REMARKS/ARGUMENTS

Application No. 09/661,725
Amendment dated December 18, 2003
Reply to Office Action of October 2, 2003

FIG. 1

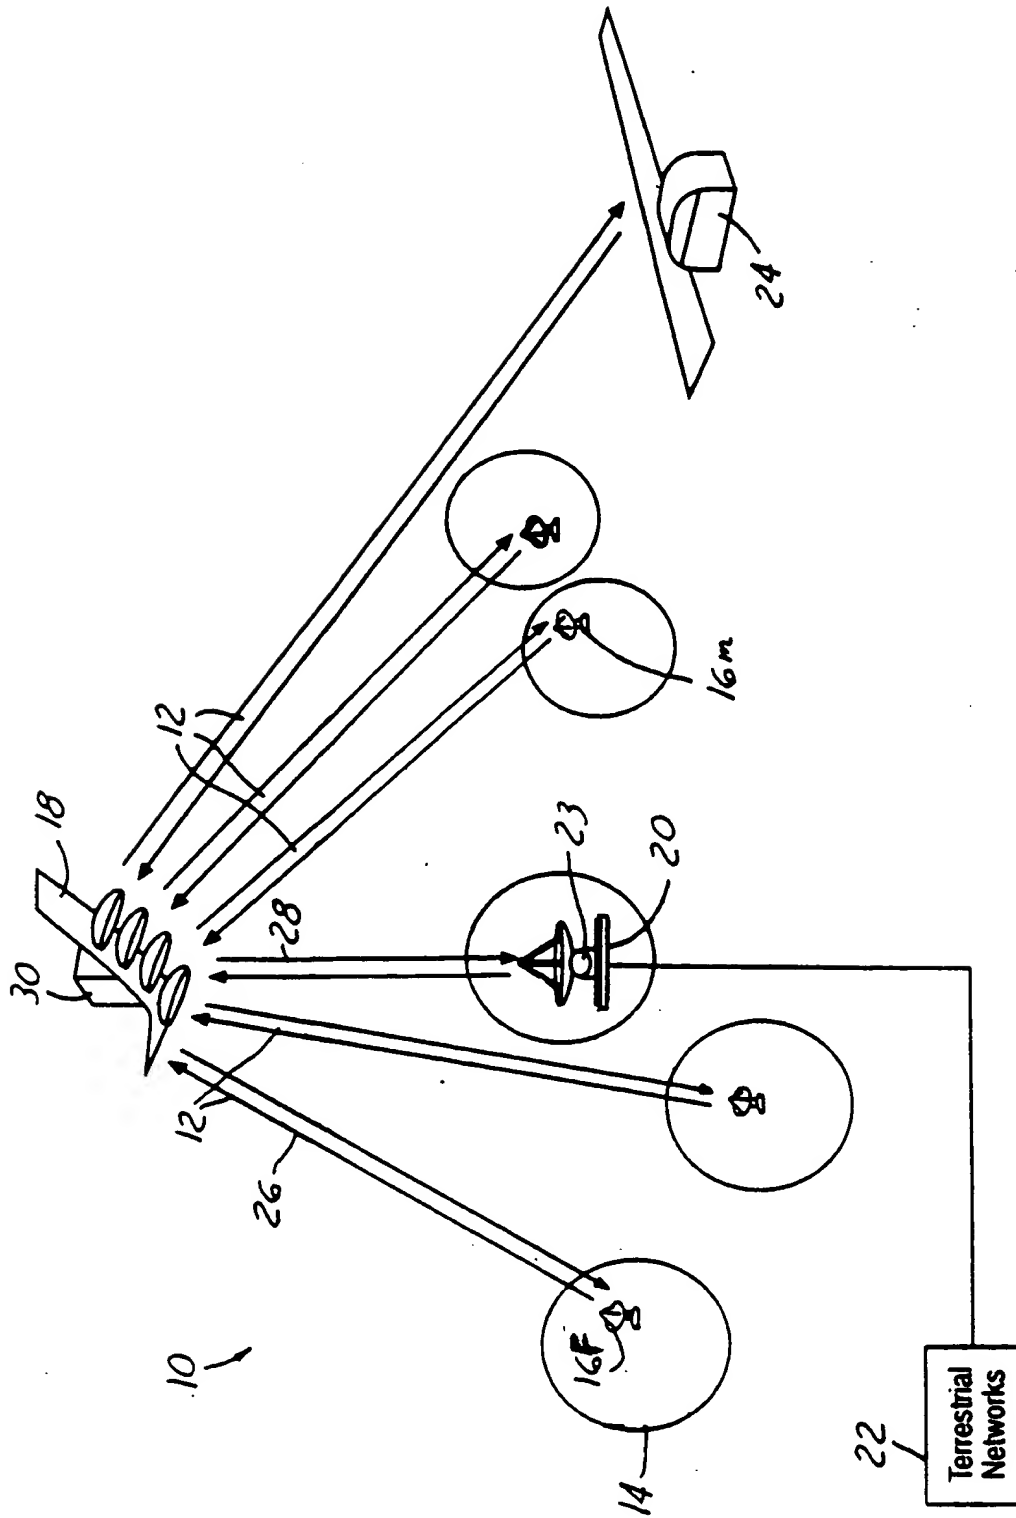
Two figures have been amended. In Fig. 1, "F" has been added after reference numeral "16". See page 6, lines 9 and 10 stating that a "plurality of user terminals 16M and 16F are used to illustrate mobile users and fixed users, respectively". In Fig. 4, the previously omitted reference numeral "78" has been added and "ANTENNNA" has been corrected to read "ANTENNA". See page 10, lines 11-14, including the reference to "main array antenna elements 78".
